**LANDSCAPE DESIGN INTENT**

FAIRFIELD  
RESIDENTIAL

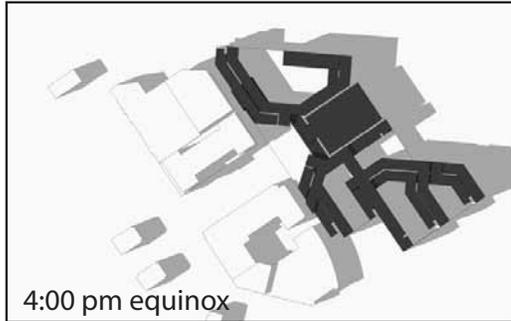
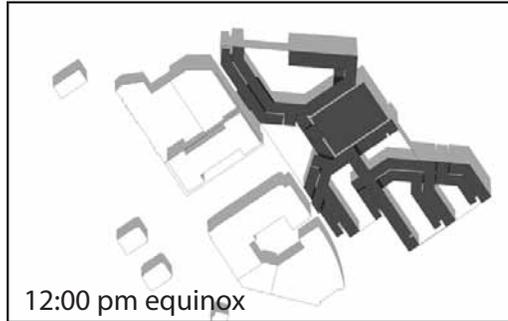
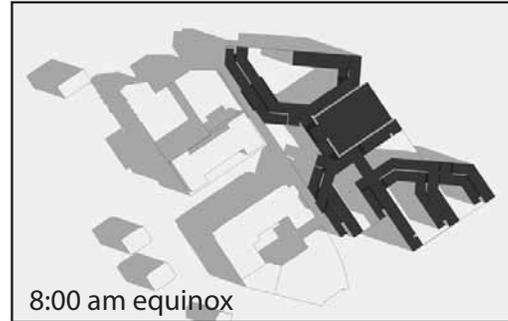
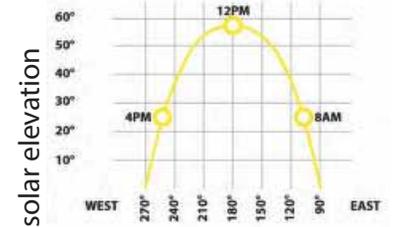
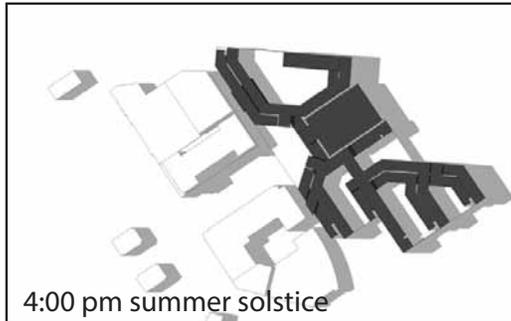
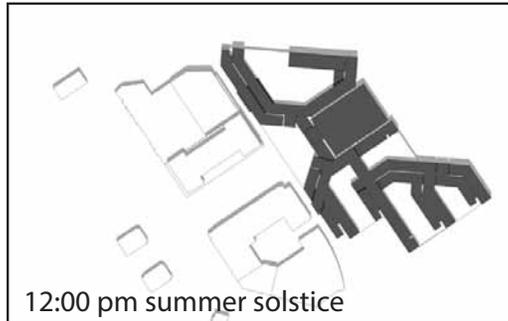
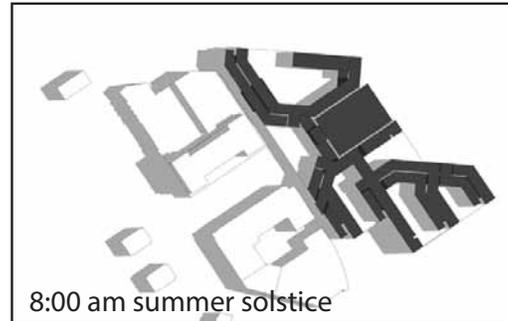
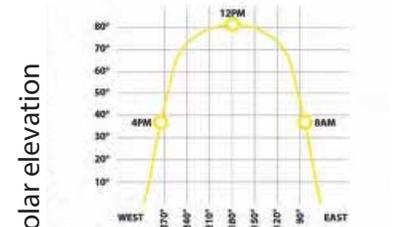
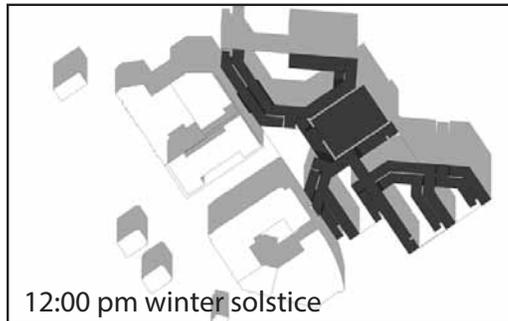
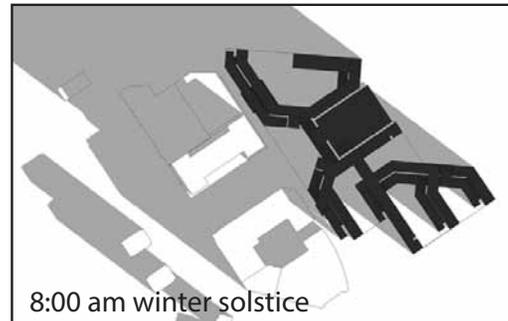
**DRB COMMENT:**

Provide shadow study.

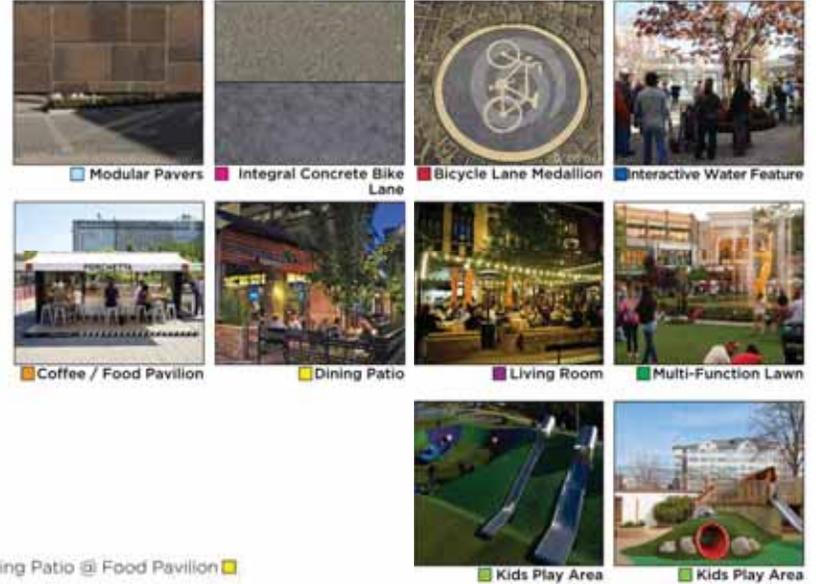
**DRB COMMENT:**

Request for updated plaza design. Would like to see a better relationship to human scale. Encourages articulation and modulation of the buildings surrounding the plaza. Consider recesses and areas for the public realm.

Dining Patio @ Food Pavilion ■

Village Living Room w/ Fire Element & Lounge Seating ■

**DESIGN TEAM RESPONSE:**

Refer to revised plaza layout including areas for outdoor seating adjacent to the retail spaces as well as programmed areas for gathering and lounging including a water feature.

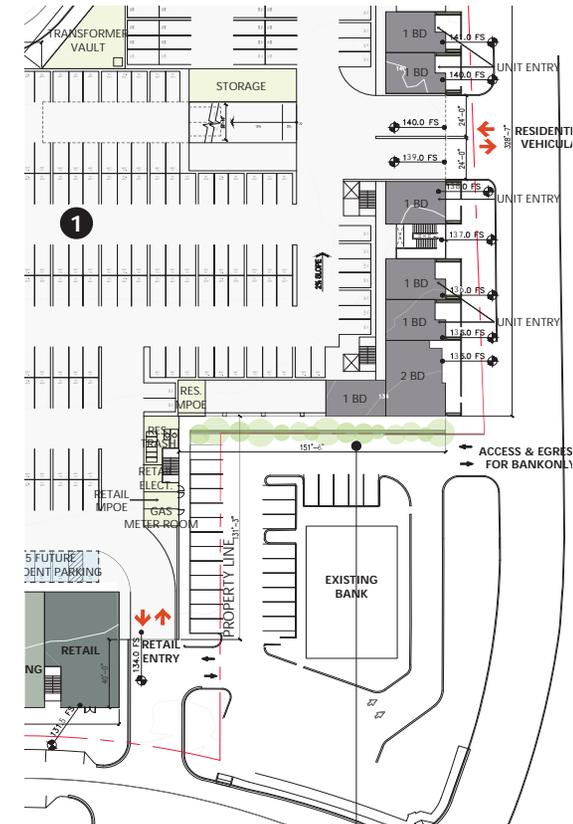
**DRB COMMENT:**

The proposed west façade behind the Chase Bank still feels institutional with a large expanse of hardie board. The white building is too much of a focal point. Also can the project have that many windows where the building is in close proximity to the property line and be in conformance with the building code?

**DESIGN TEAM RESPONSE:**

A revised concept in this area includes repositioning the single loaded corridor to the courtyard side to allow for better articulation of this prominent façade. The prior single flat plane has been redesigned to allow for setbacks that create balcony conditions. The materiality has been enhanced with the introduction of brick and the elimination of hardie board at this location. The fenestrations at the parking levels continues the rhythm of the residential levels above and the corner has been better defined. The setback from the property line has been increased from 5 to 10 feet to allow for a higher percentage of openings allowed.

- metal panel  
(oxidized brown)
- brick replaces  
hardie board
- garage  
screens
- new setbacks  
creating balconies
- new setbacks

Building with 10' setback from property line
